**TO:** HEARINGS OFFICER

**SUBJECT:** VARIANCE / CLASS 2 DRIVEWAY APPROACH CASE NO. 21-01;  
1355 MILDRED LANE SE- 97306;  
AMANDA NO.: 21-101587-ZO, 21-101590-ZO

Summary: A request for a Variance and Class 2 Driveway Approach Permit to allow a driveway approach onto Mildred Lane SE, a Minor Arterial Street, where a driveway is not allowed for a single-family residential use.

SITE PLAN  
SCALE: 1" = 20'-0"

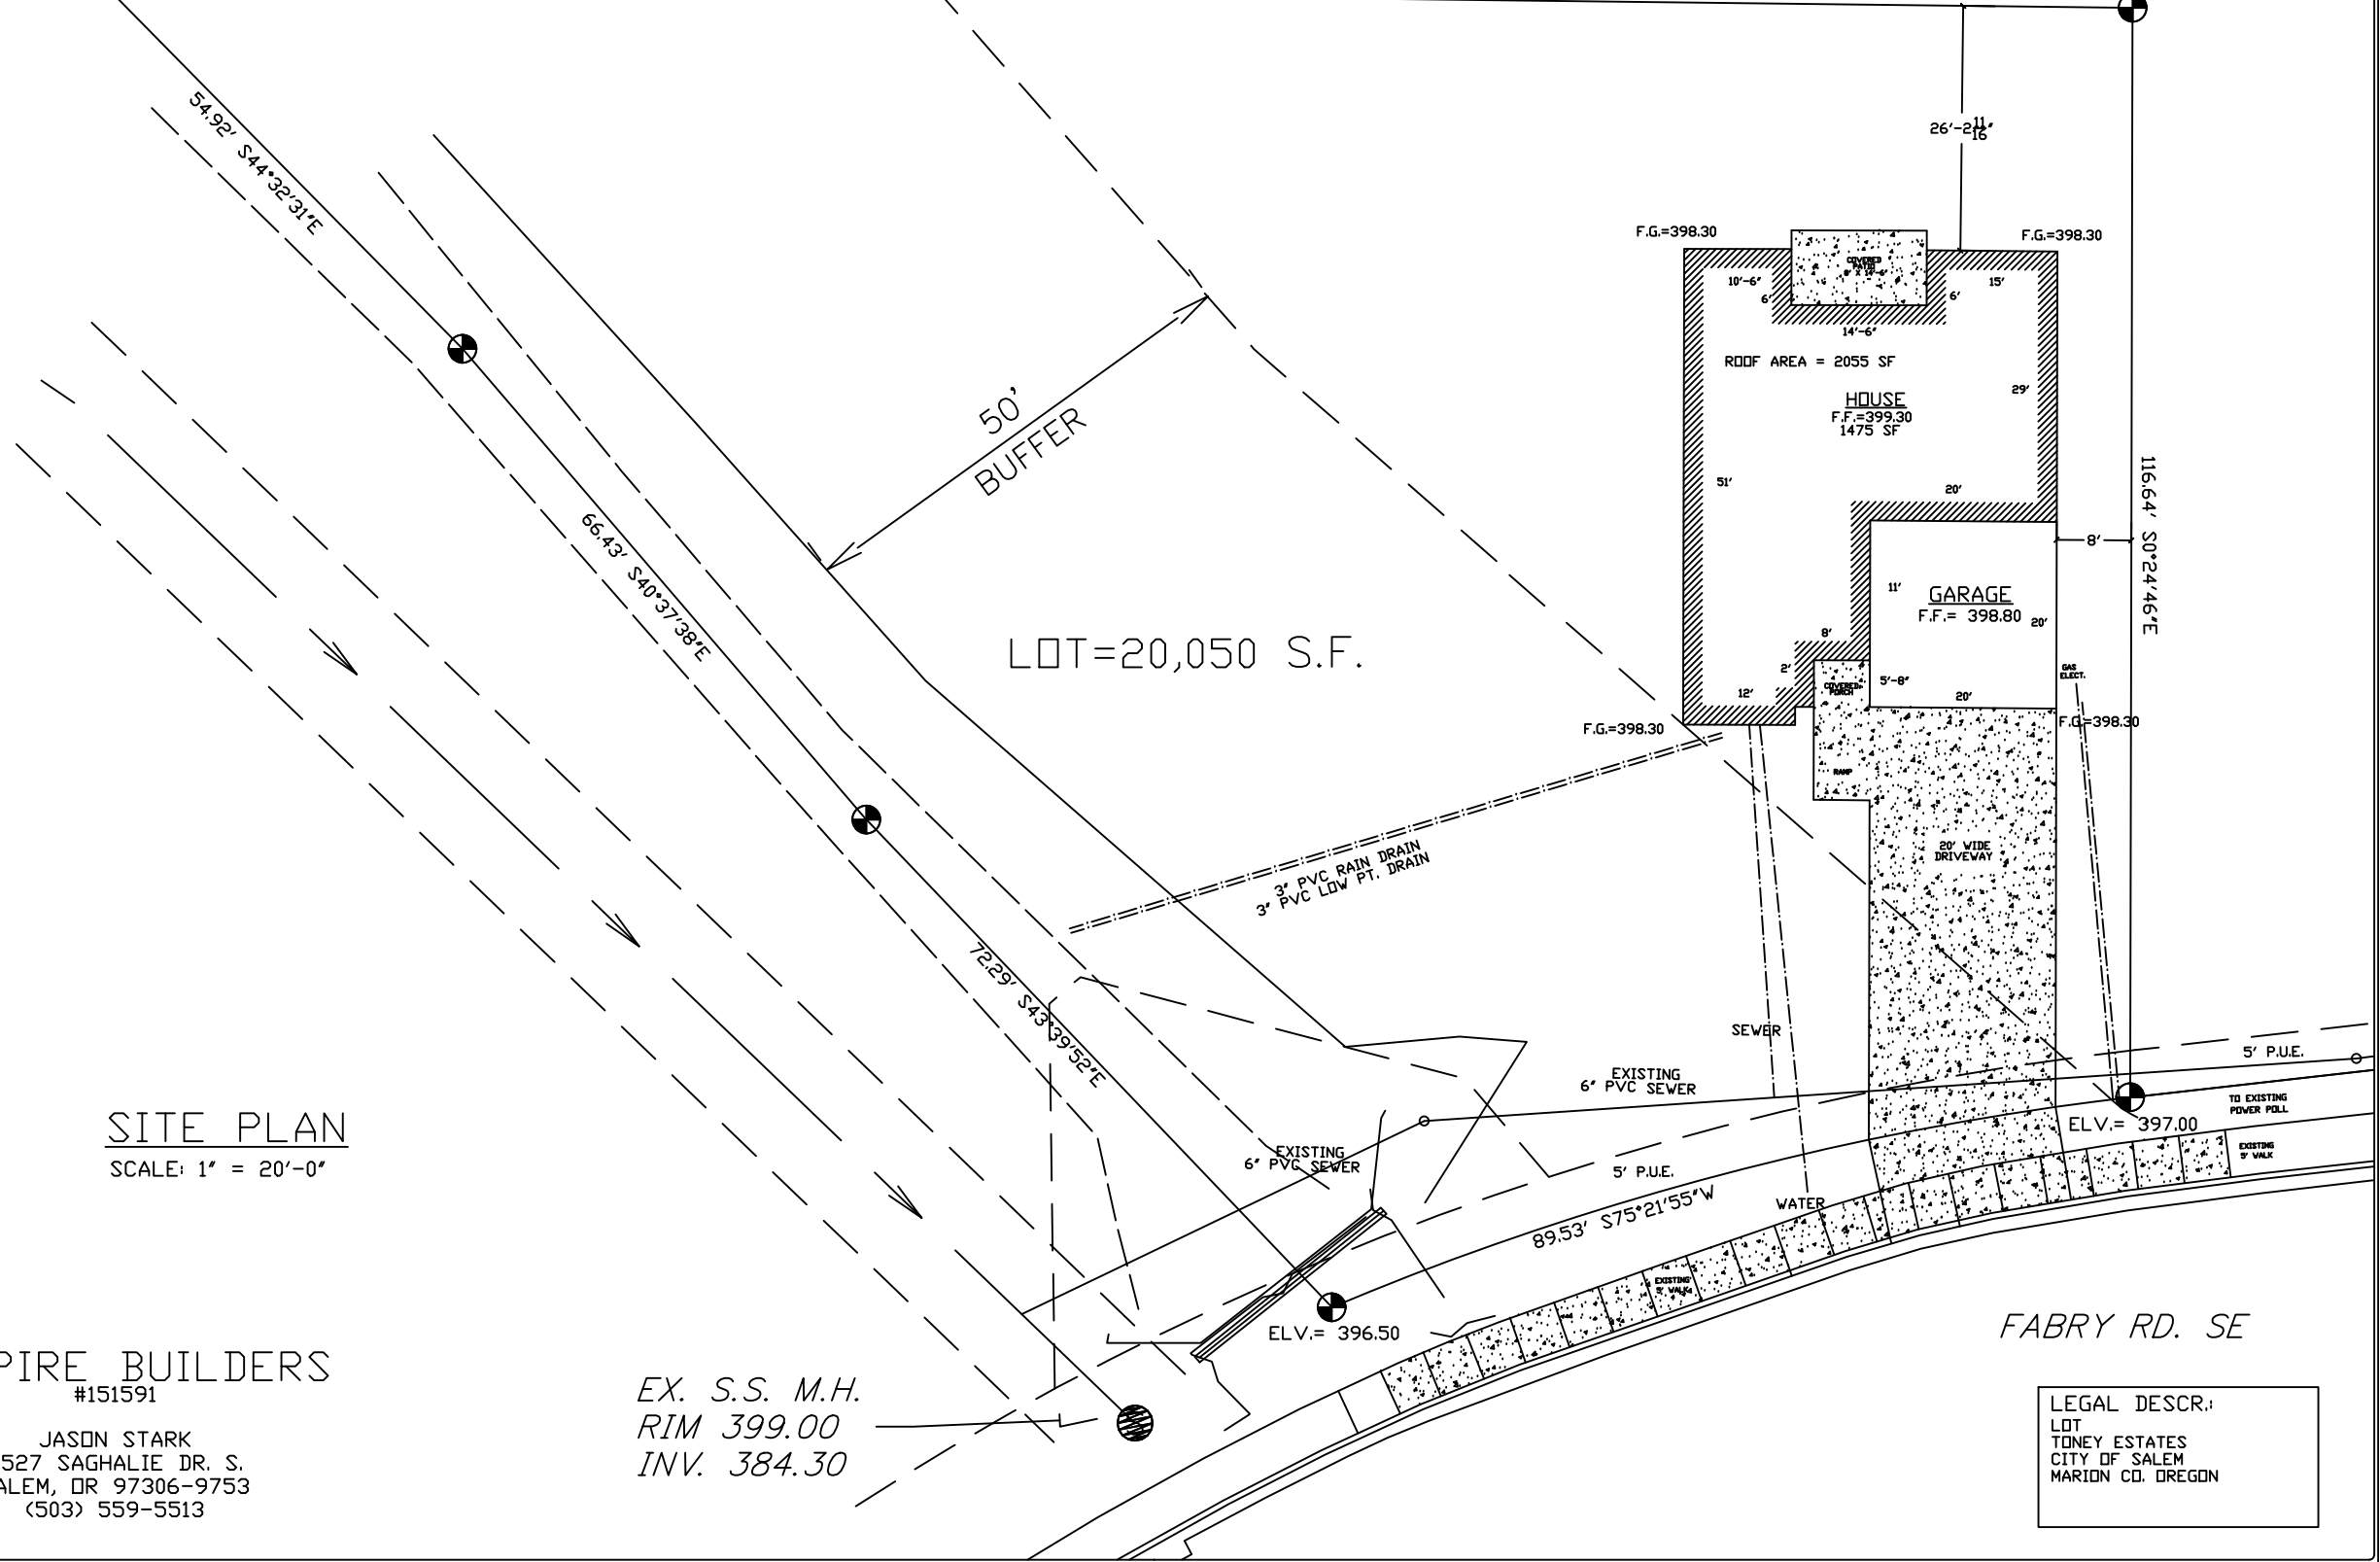
The applicant's site plan indicates a driveway approach and single-family dwelling are proposed for a portion of a lot (Parcel 1) that was approved under Partition Case No. PAR19-11. However, the partition plat has not been recorded, therefore, Parcel 1 is currently not a legal parcel and the applicant's site plan only shows a small portion of proposed Parcel 1 which is a lot configuration that is nonexistent. The applicant has not provided any details about their future plans for the remainder of proposed Parcel 1, which makes an analysis of the proposal difficult.

Staff notified the applicant on January 27, 2021 that the site plan does not reflect the total site area and dimensions as required under SRC 245.005(c)(1) and requested a revised site plan. On January 29, 2021, the applicant provided written notice stating no additional information would be provided pursuant to ORS 227.178(2)(c) and requested that the applications be deemed complete as submitted. The applications were deemed complete for processing on January 29, 2021. The site plan submitted with the variance application does not meet the additional submittal requirements of SRC 245.005(c)(1).

Pursuant to SRC 804.035(c)(4), a Minor Arterial access shall allow only forward-in/forward-out movements. The proposed site plan shows a driveway that requires vehicles to back out into Mildred Lane SE. This standard is not met.

**Staff Finding:** The proposed site plan shows a driveway that requires vehicles to back out onto Mildred Lane SE (a Minor Arterial). Table 3-1 of the Salem Transportation System Plan classifies a minor arterial street as a high capacity street that primarily serves regional and intracity travel with an Average Daily Traffic (ADT) count of 7,000 to 20,000 vehicles. The proposed driveway access for the single-family use onto Mildred Lane SE, a high capacity street, is not allowed pursuant to SRC 804.035. Further, the applicant's site plan does not show adequate turnaround onsite which would result in vehicles having to back out onto Mildred Lane SE. Backing out onto a high capacity street would not provide for safe turning movements and access and could potentially create traffic hazards. This criterion is not met.

**PROPOSED  
PARTITION PLAN**

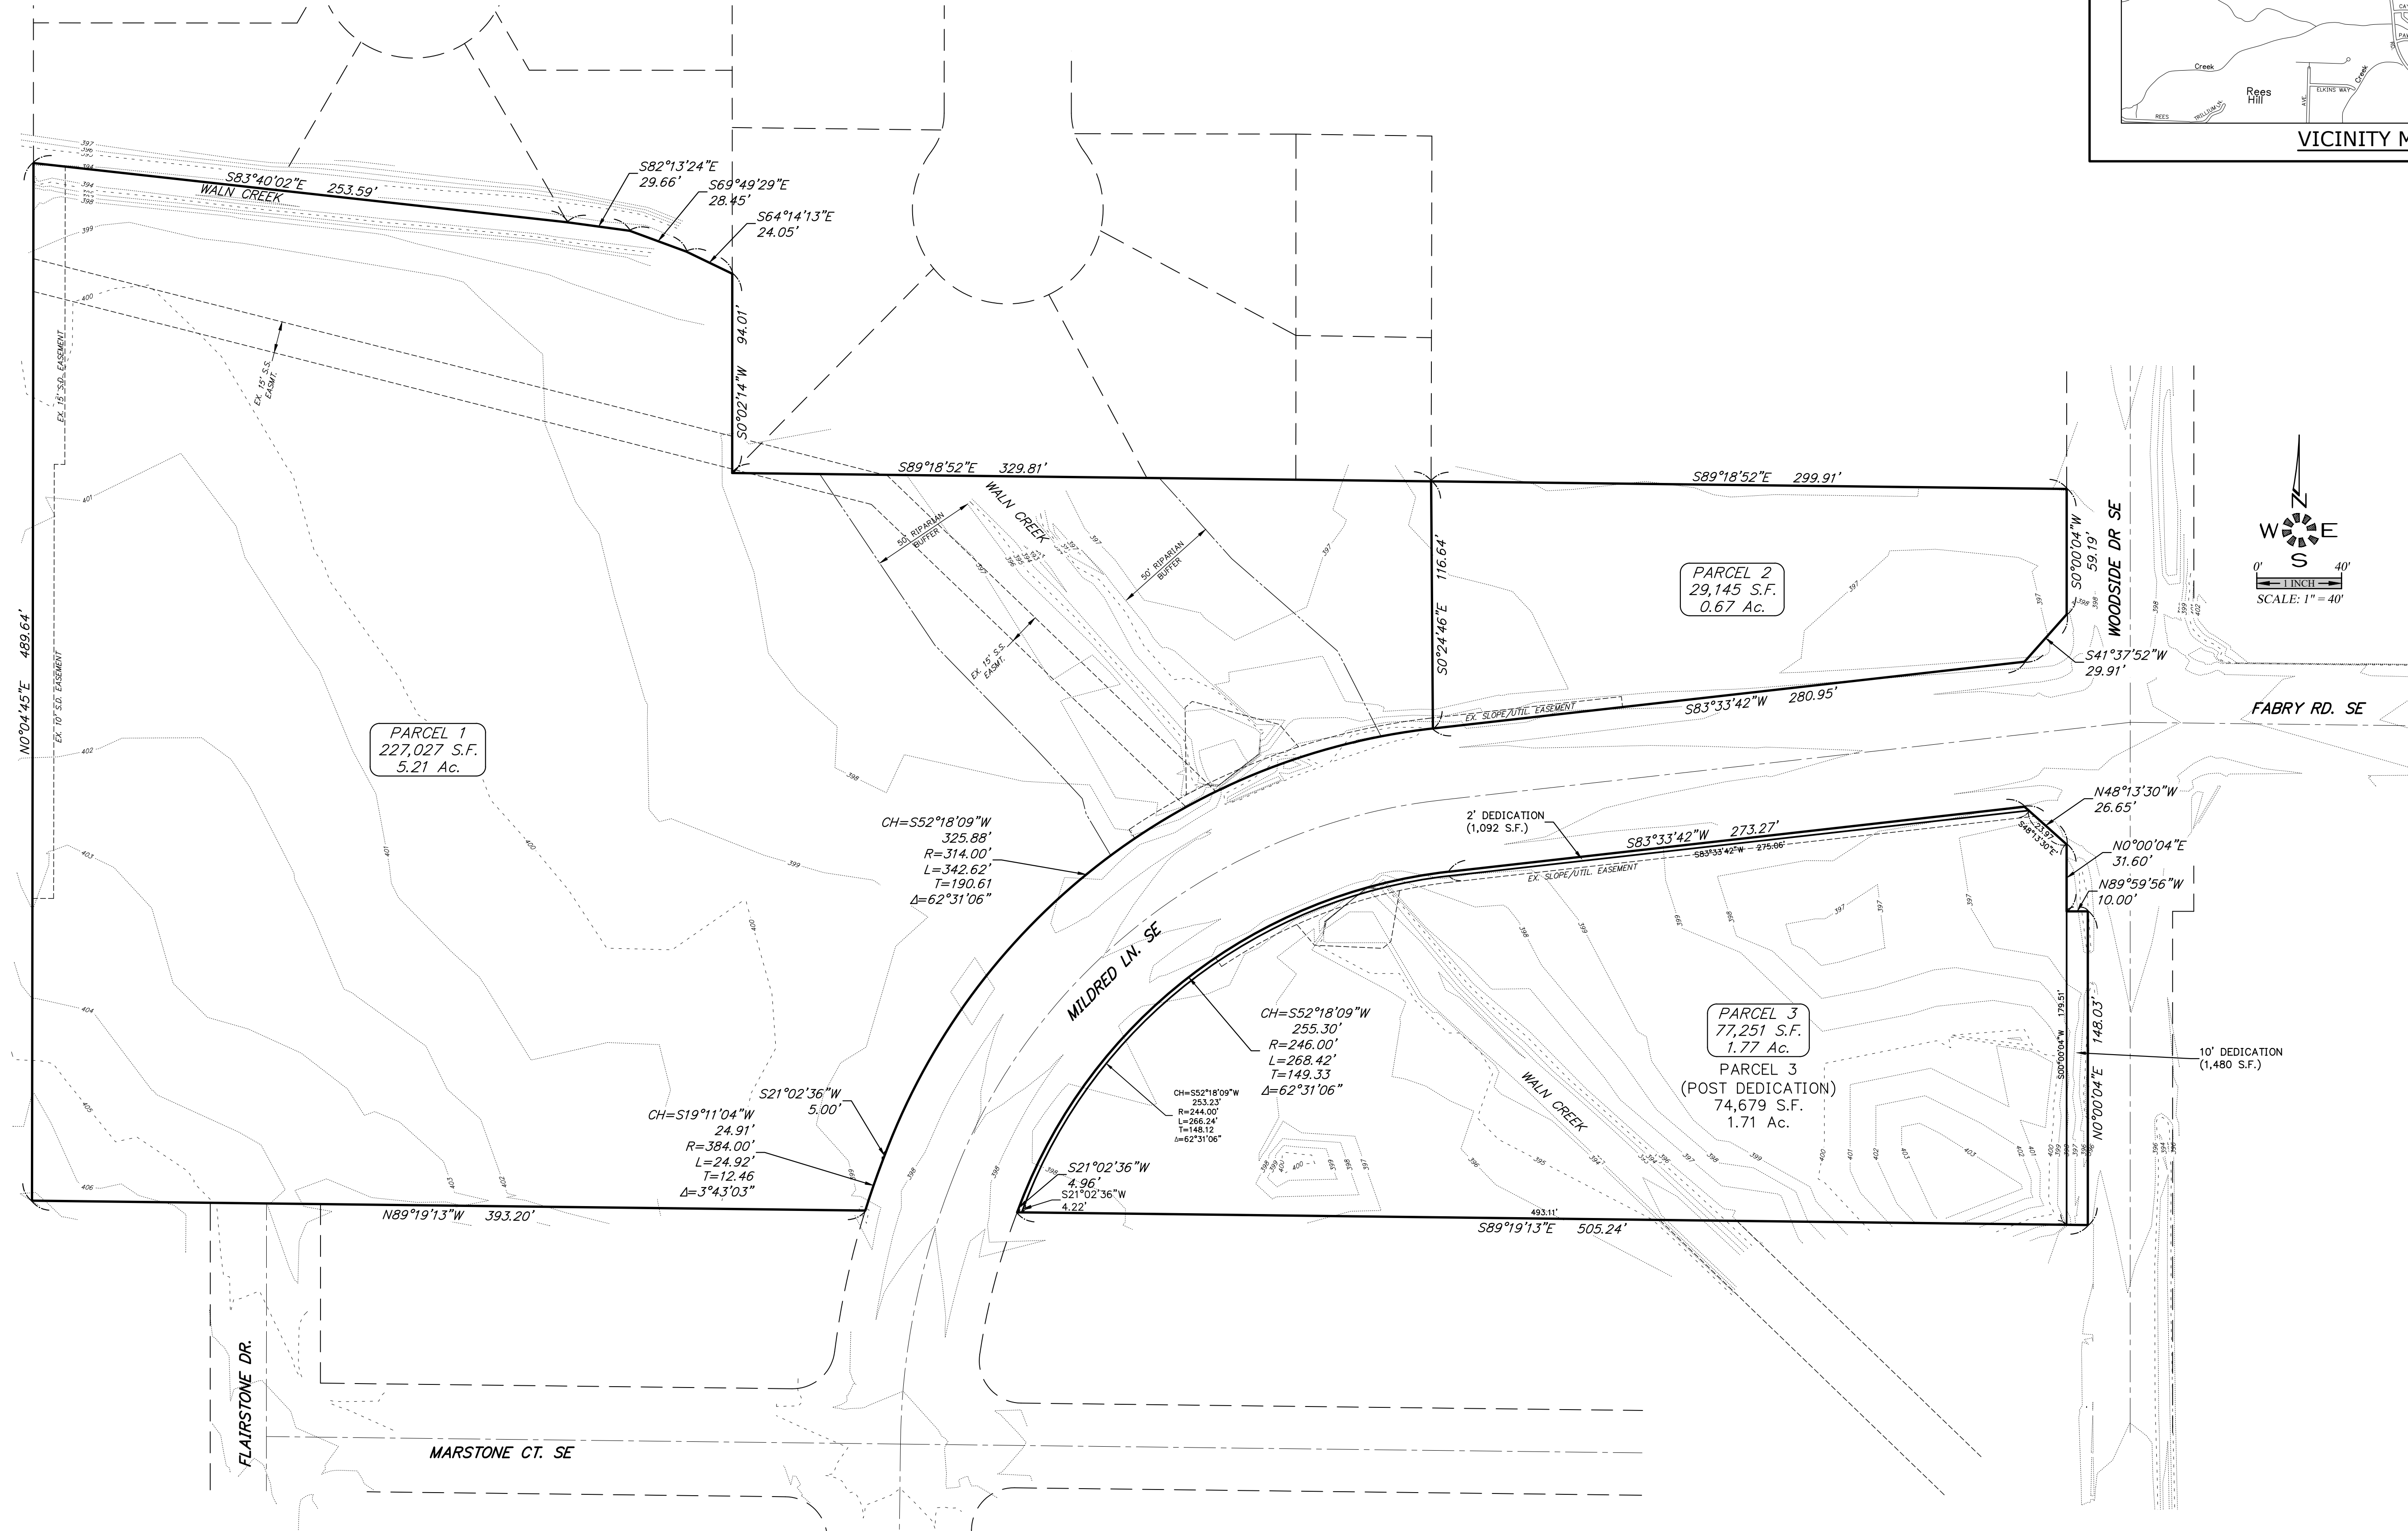
The subject property was approved for a three-lot partition in August of 2019; Partition Case PAR19-11 (**Attachment D**). The proposed driveway approach is to provide access for a new single-family dwelling submitted for development under permit 20-113775-DW. The applicant's site plan indicates the driveway approach and single-family dwelling are proposed for a portion of proposed Parcel 1 of PAR19-11. However, the partition plat has not been recorded, therefore, Parcel 1 is currently not a legal parcel. Partition tentative plans are valid for a period of two years. The approval granted by PAR19-11 must be exercised or an extension granted by September 14, 2021, or the approval will be null and void. Pursuant to SRC 300.850, Table 300-3, a partition tentative

**Staff Finding:** The subject property is approximately 7.6 acres in size and is currently vacant. Partition Case No. PAR19-11 approved subdividing the 7.6-acre parcel into three smaller parcels, however, the partition plat has not been recorded, therefore, Parcel 1 is currently not a legal parcel. Additionally, the applicant's site plan illustrates a lot configuration that is nonexistent and therefore, not a legal lot. The development, as submitted, is not allowed. SRC 804.035(a)(2)(B) and (C) provides that no driveway approach is allowed onto a major or minor arterial unless the development does not abut a local or collector street; or the development cannot be feasibly served by access onto a local or collector street.
